Groundwater Management District #5

Technical Assessment of City of Hays Water Transfer/ R9 Ranch Development Scenarios and Commentary on WaterPACK Analysis

BBGMODMOD simulation result with proper stream network connectivity

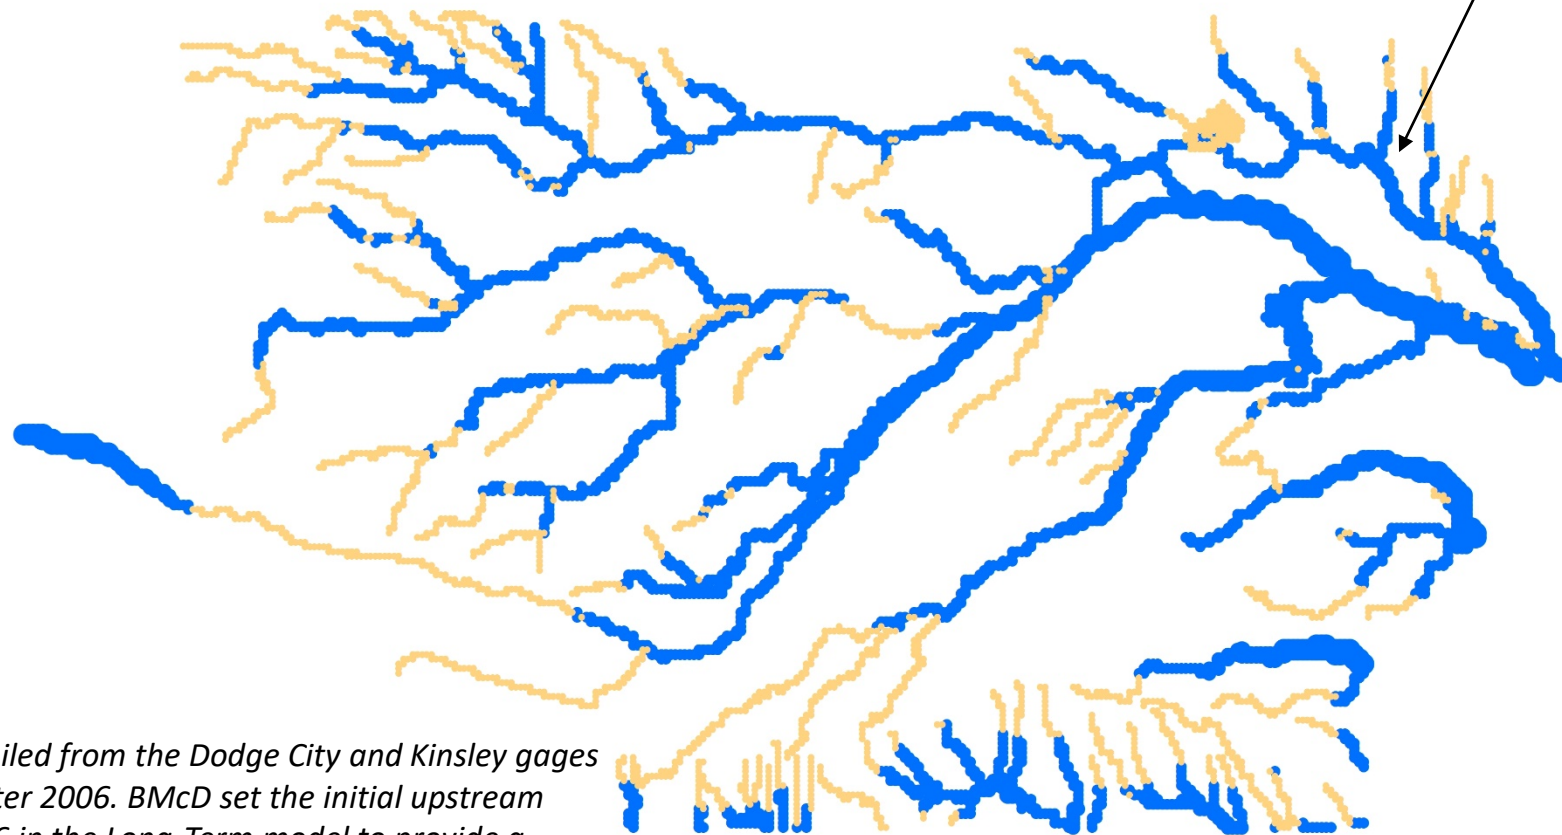
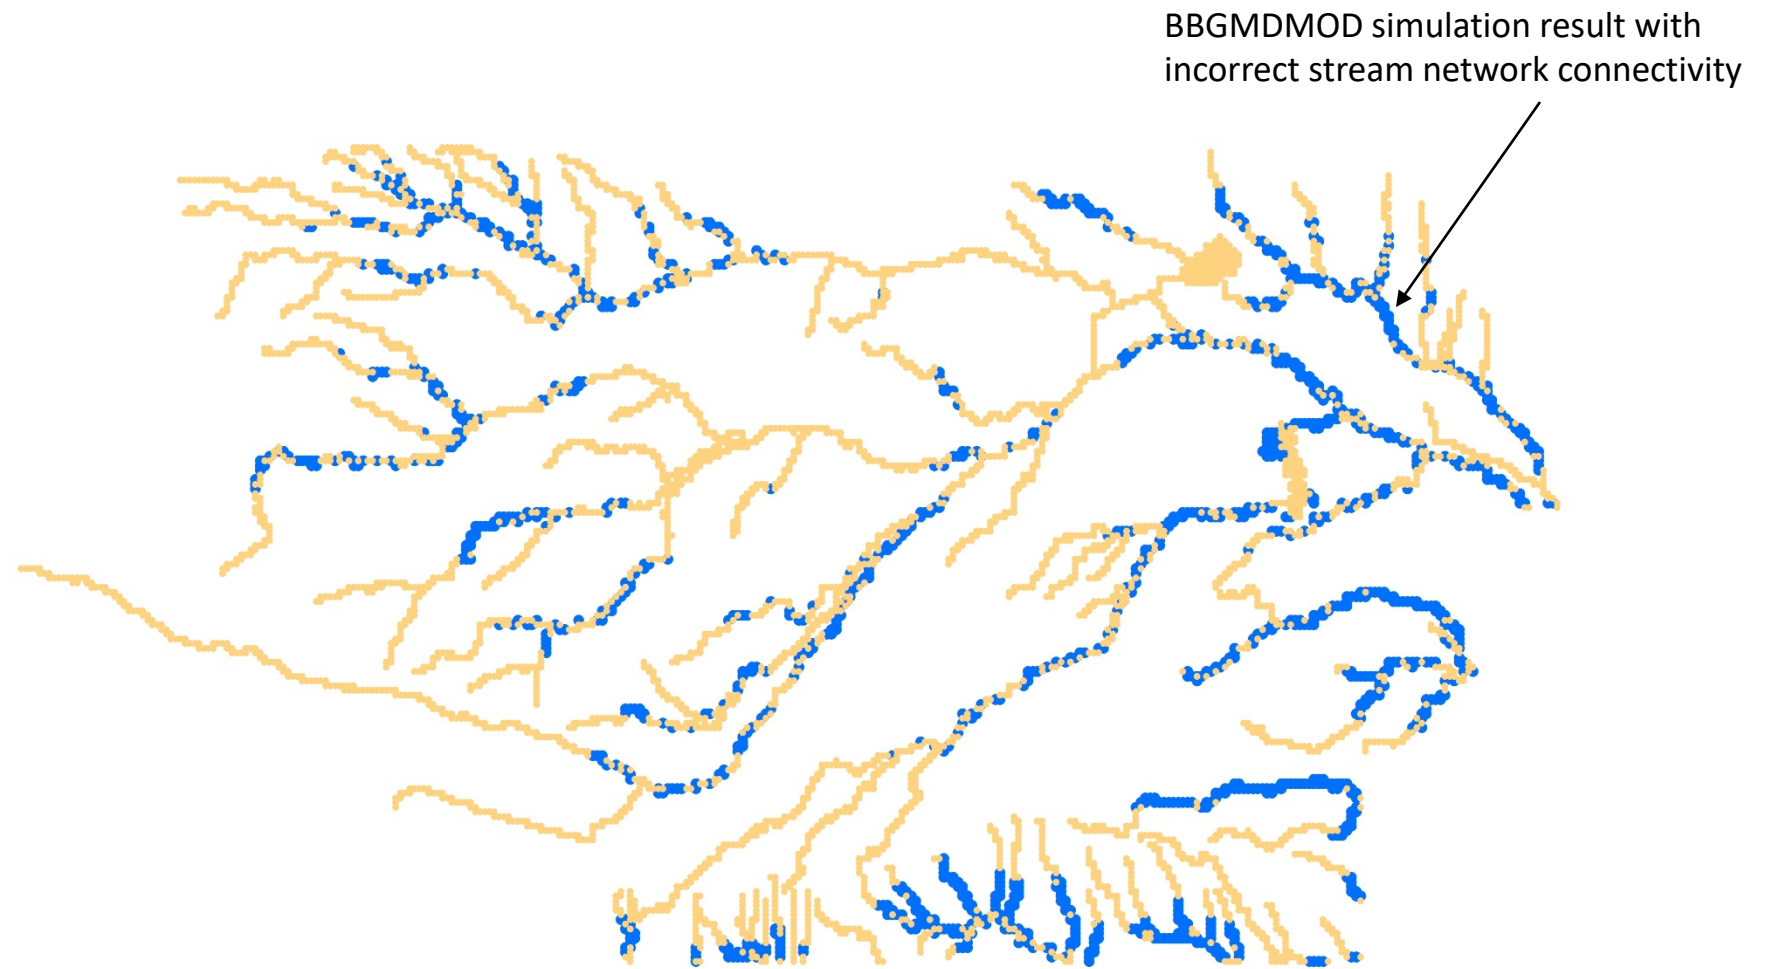
The GMD#5 model is calibrated with recharge from streams that requires routing of downstream flow.

BMcD report, P. 8

“Historic flow data in the Arkansas River compiled from the Dodge City and Kinsley gages reflect a significant decrease in streamflow after 2006. BMcD set the initial upstream flow in the Arkansas River to zero after year 16 in the Long-Term model to provide a conservative estimate and to recognize changing conditions resulting in reduced flows in the Arkansas River. Baseflow can still occur if the model calculated water level elevation in the aquifer rises high enough to cause the aquifer to discharge to the River. If that occurs, the streamflow routing package will calculate a discharge from the aquifer to the stream and generate baseflow for the River.”

When BMcD set the initial upstream flow in the simulated river to zero (at year 16), the streamflow routing was disabled to create the incorrect stream network connectivity shown above.

Comment on BMcD Simulation of Stream Stage and Stream Flow Routing

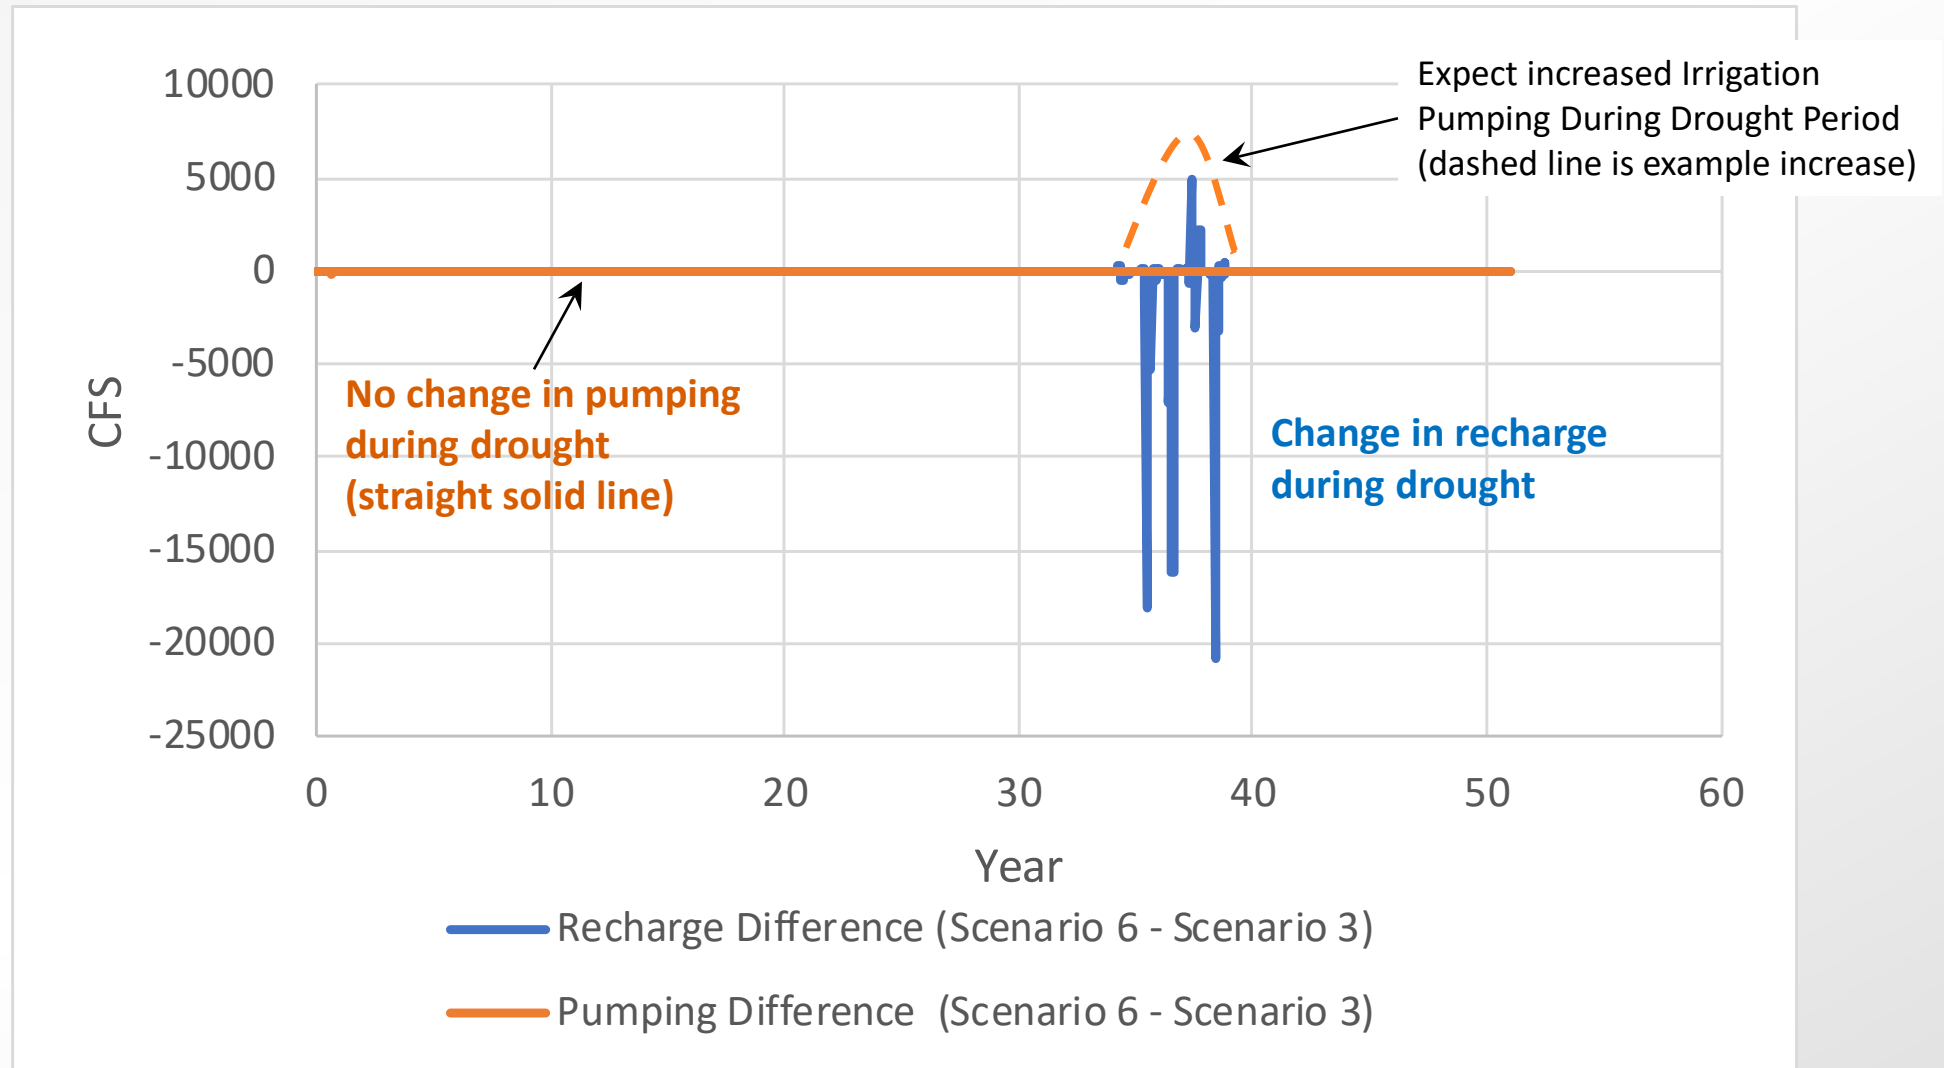
Stream Stage:

On the average, the simulated stream stages in the BMcD analysis results in regionally incising the streambed a couple of feet in comparison to the calibrated model. This can explain the increased flow simulated at Kinsley gage during low-flow periods (lowering the streambed would induce river flow from shallow groundwater). The issue occurs in both the retrospective and the prospective BMcD analyses.

Stream Flow Routing (SFR):

SFR in the GMD#5 model is the mechanism for aquifer recharge along streams (derived from regional runoff) in the model area. SFR also accounts for flow in the modeled streams. The issue occurs in the BMcD prospective analyses.

The two model adjustments above change the model in a way that may or may not significantly alter the simulated flow regime. The bottom line is that if BMcD were to address the issues by repairing the modeled stream stage and the SFR, their updated results might not be significantly different. The reason is the BMcD model scenarios are based on a difference between two simulations and even though each simulation has an issue with stream stage and SFR, the difference between the scenarios may not be very different from the difference between two simulations with corrected issues. This point can be definitively clarified by re-running the BMcD scenarios with stream stages and SFR that matches the original GMD#5 model (as BMcD reportedly intended).

The BMcD stream stage and streamflow routing (SFR) issues constitute a breakdown in running the GMD#5 model in its calibrated form. It is possible that if the issues are addressed, the BMcD analysis results will not significantly change. However, a technical addendum that addresses the issues should be made to confirm the analysis results as part of the record.

Comment on BMcD Simulation of Scenario 6 Drought Condition

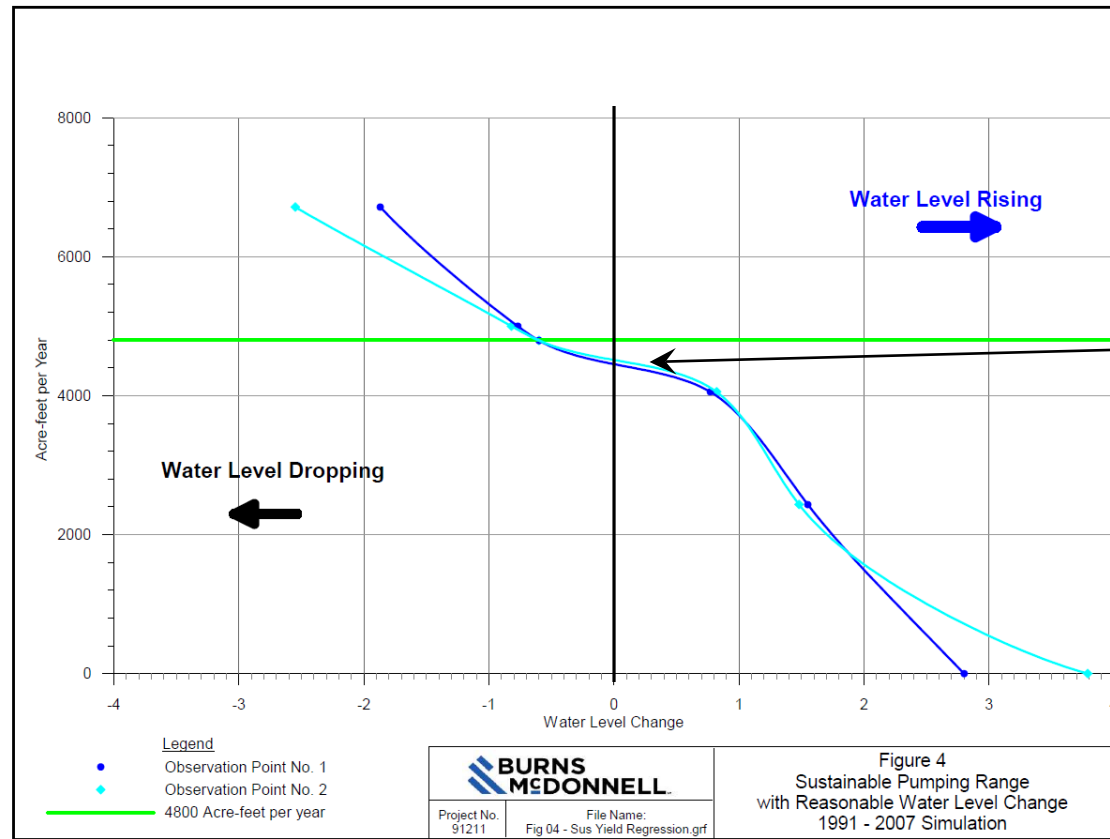
BMcD analysis considers a 5-year drought (Scenario 6) over years 35 to 39 of the simulation. The drought condition is represented by reduced recharge, but without an associated increase in pumping at regional irrigation wells.

It is odd to apply drought conditions to simulated recharge and to the R9 Ranch municipal wells, but not to the other irrigation wells in the area.

The same technical concept of a difference between two scenarios, previously described for the stream stages and SFR, occurs here. That is, it is possible that if BMcD were to add drought conditions to area irrigation wells and re-run Scenario 6, the results might not significantly change. An actual simulation is necessary to clarify this.

BMcD Scenario 6 considers drought conditions on use of the municipal wells at the R9 Ranch. However, the drought condition is not considered at other area irrigation wells. Consideration of drought conditions in that context would provide a more comprehensive drought analysis for planning purposes. It is possible that re-running may produce similar results despite the better scenario.
